JWA MARK-UP
14 OCT 2011
STUDIO STRATEGY

Client: University of Melbourne
Parkville Campus

Project: Faculty of Architecture
Building and Planning

Title: GENERAL ARRANGEMENT
LEVEL 01 FLOOR PLAN - LO

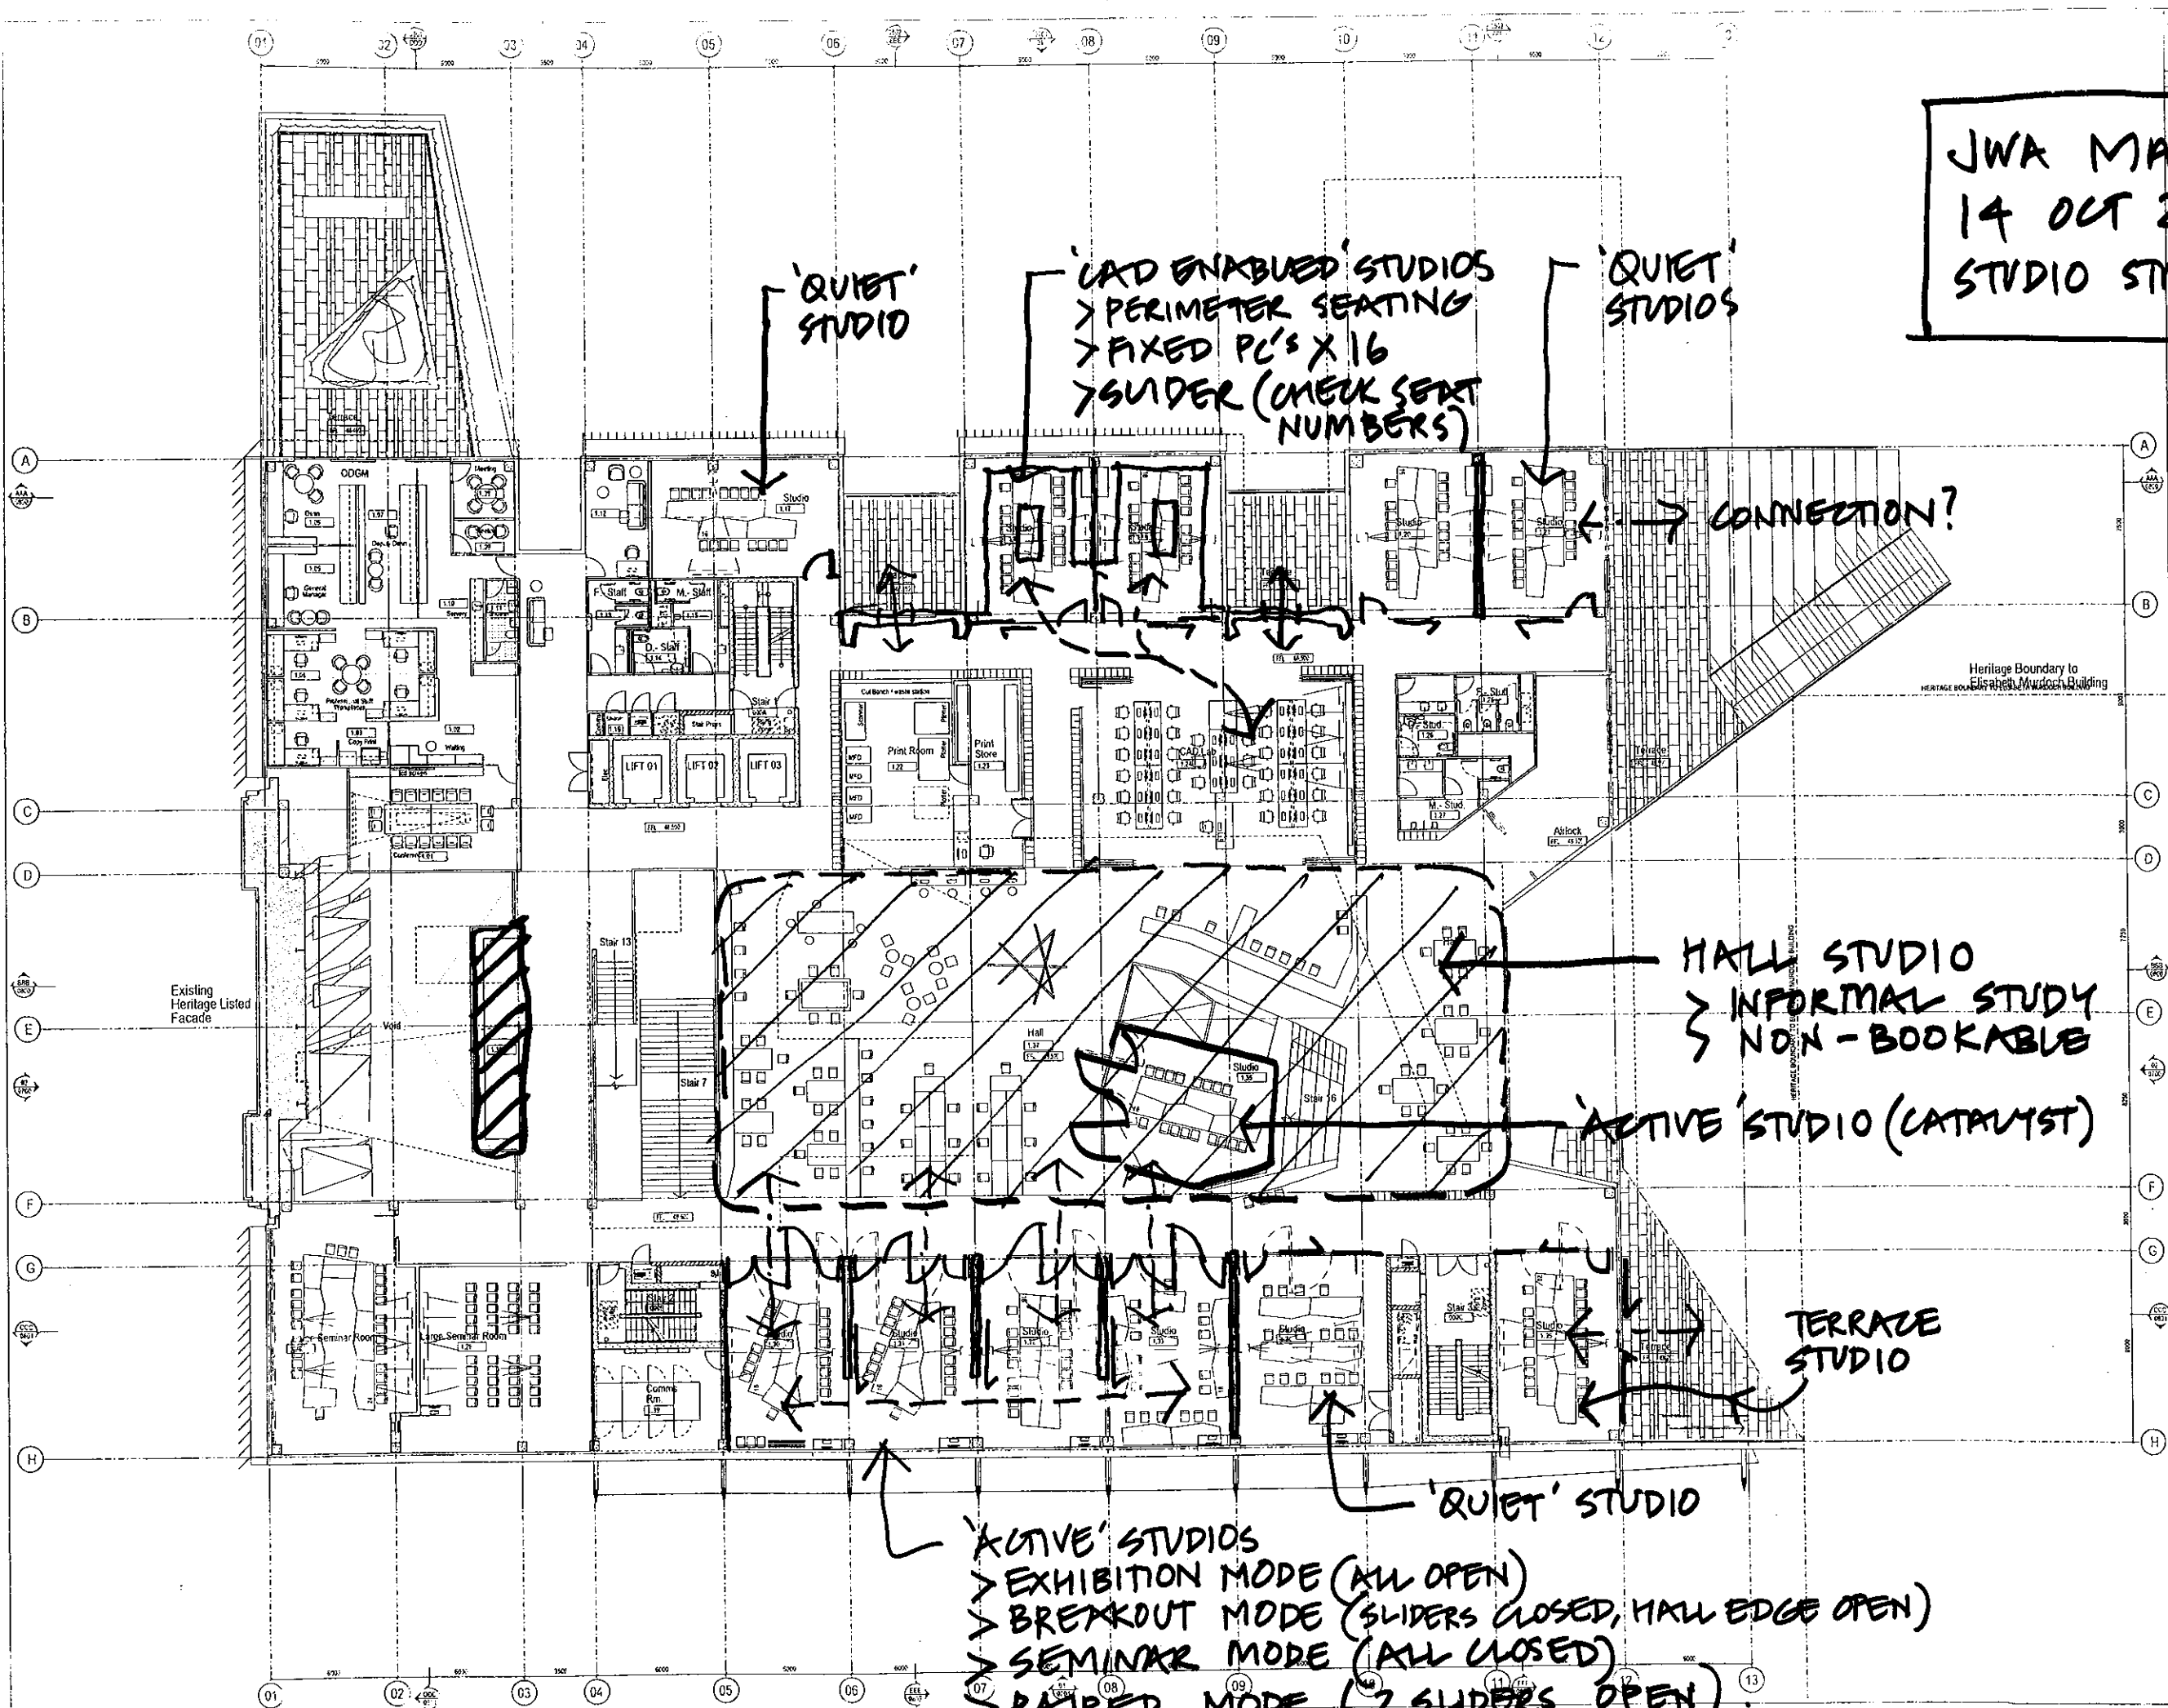
'CAD ENABLED' STUDIOS
> PERIMETER SEATING
> FIXED PC'S X 16
> SLIDER (CHECK SEAT NUMBERS)

CONNECTION?

'ACTIVE' STUDIOS
> EXHIBITION MODE (ALL OPEN)
> BREAKOUT MODE (SLIDERS CLOSED, HALL EDGE OPEN)
> SEMINAR MODE (ALL CLOSED)
> PAIRED MODE (2 SLIDERS OPEN)

'QUIET' STUDIOS
> SEMINAR MODE
> PAIRED MODE
(OPERABLE WALL)

DOORS?
SUSPENDED STUDIO
(CATALYST)

HATCHED AREAS
NEED TO BE
FOR SMALL
GROUPS OF
STUDENTS,
SKY 3 TO 6,
TO DO COLLABORATIVE
WORK. FINAL
LOCATIONS TBC.

'CAD ENABLED' STUDIO
7 FIXED PC'S X 16
> SLIDER (CHECK SEAT NUMBERS)

'QUIET' STUDIOS.
> NO SLIDERS BETWEEN

ACTIVE STUDIO - BREAKOUT

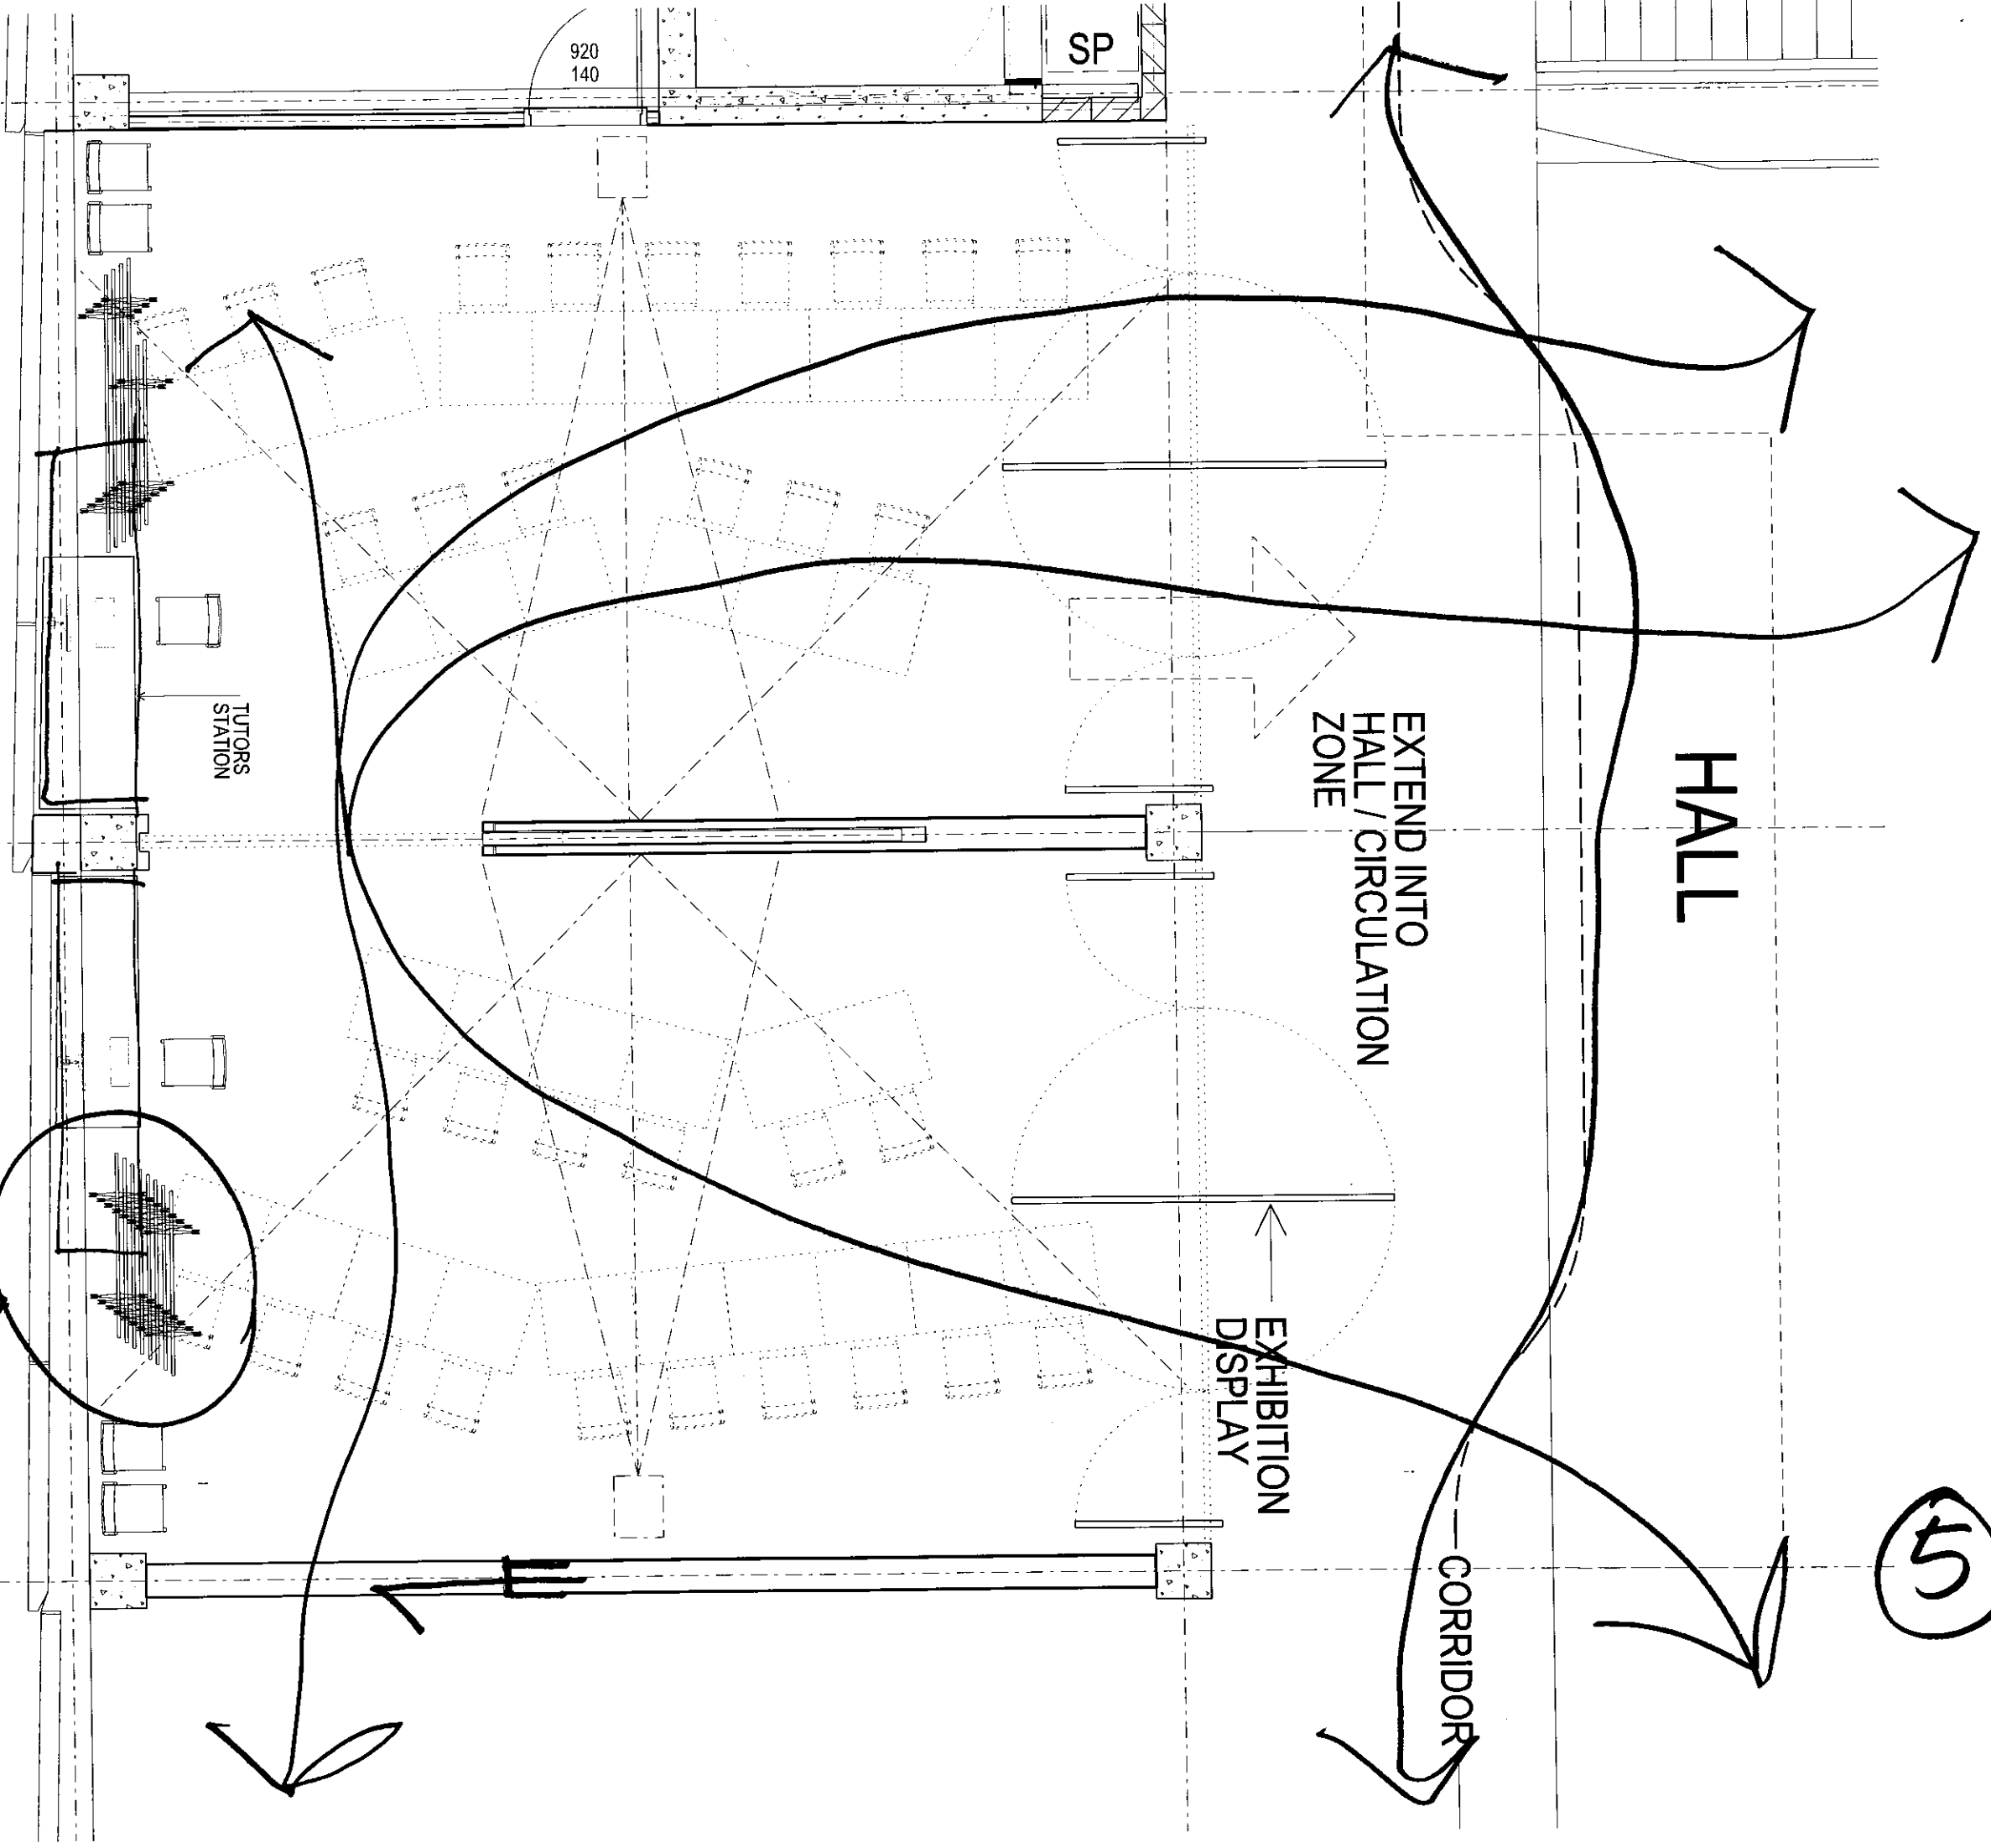
EXTEND INTO
HALL / CIRCULATION
ZONE

ACCESS
CONTROL
DOOR

CONVERSATIVE
LEARNING
LAYOUT
(GROUPS OF
4-6)

PIN UP
SURFACE
ON DOOR
BOTH
SIDES.

UNIVERSITY STANDARD
WHITE PAINTED
PROJECTION SURFACE
(2.4M WIDTH IMAGE)
OR SPECIAL PIN UP
PROJECTION SURFACE

- BAG ALLOWS
- MODEL SETDOWN
- AV & PC STATION.

ACTIVE STUDIO - EXHIBITION

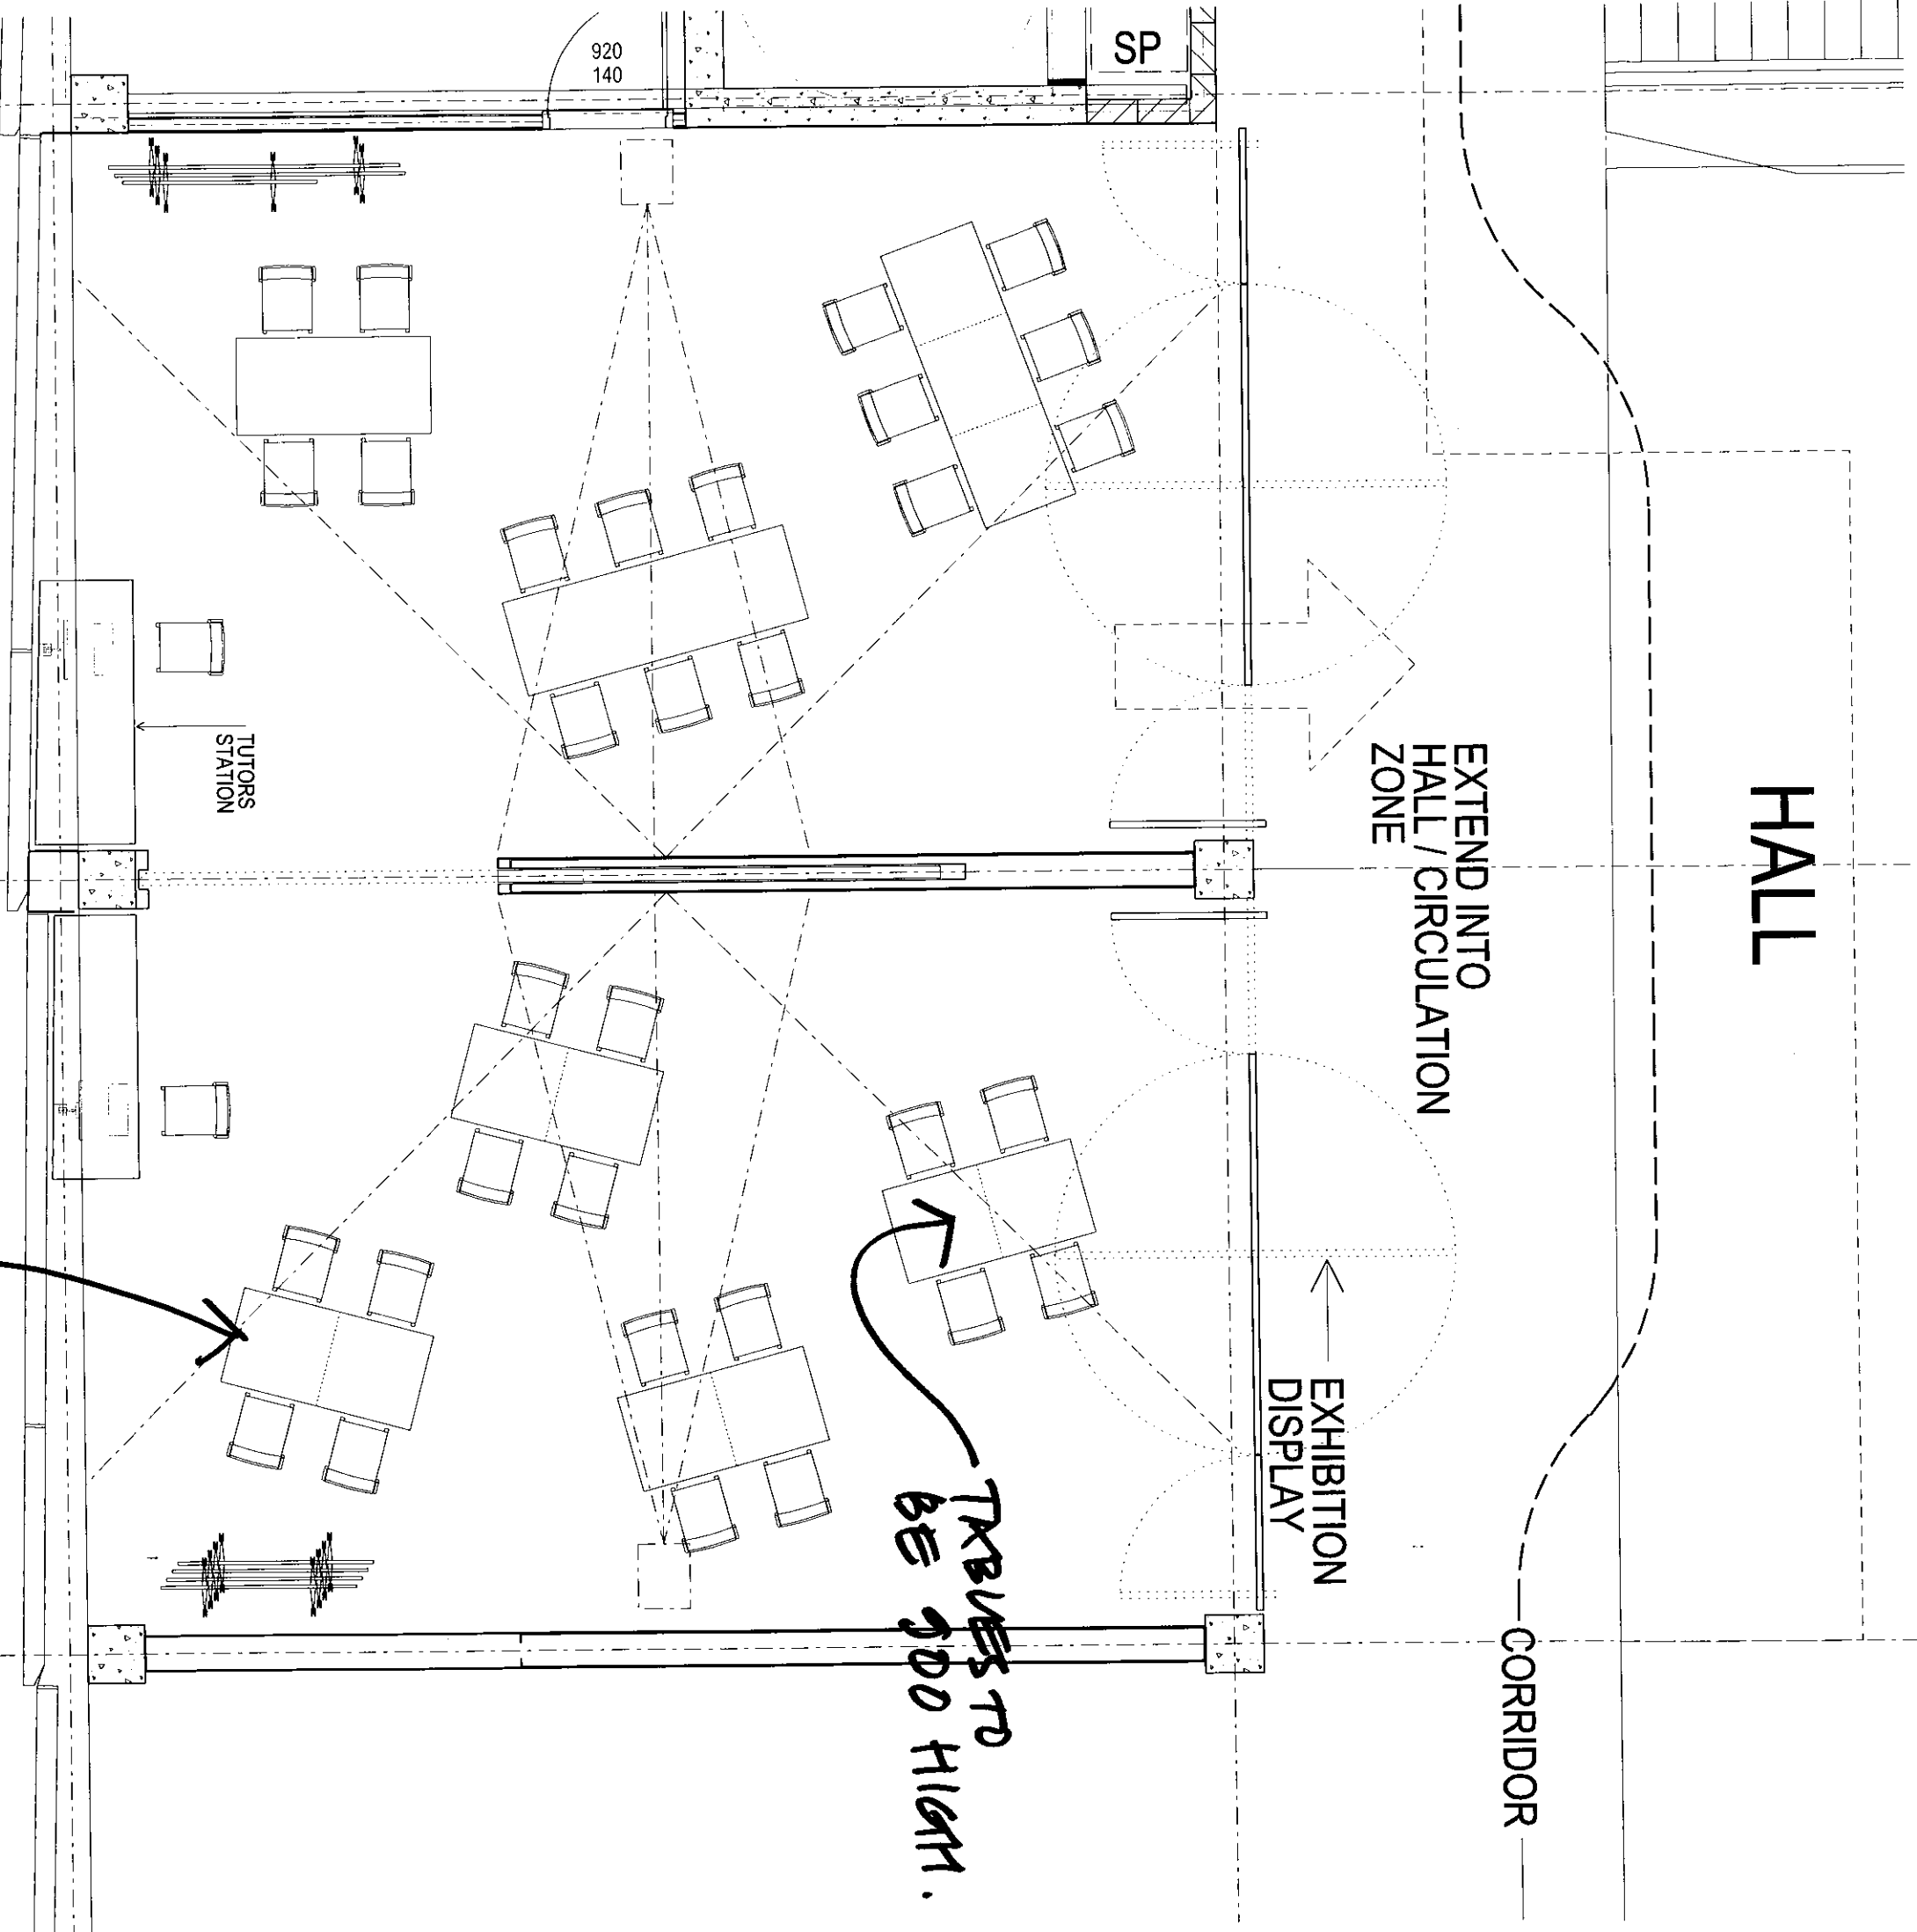
FOUR ABUSE &
STUCK ABUSE
TABLES.
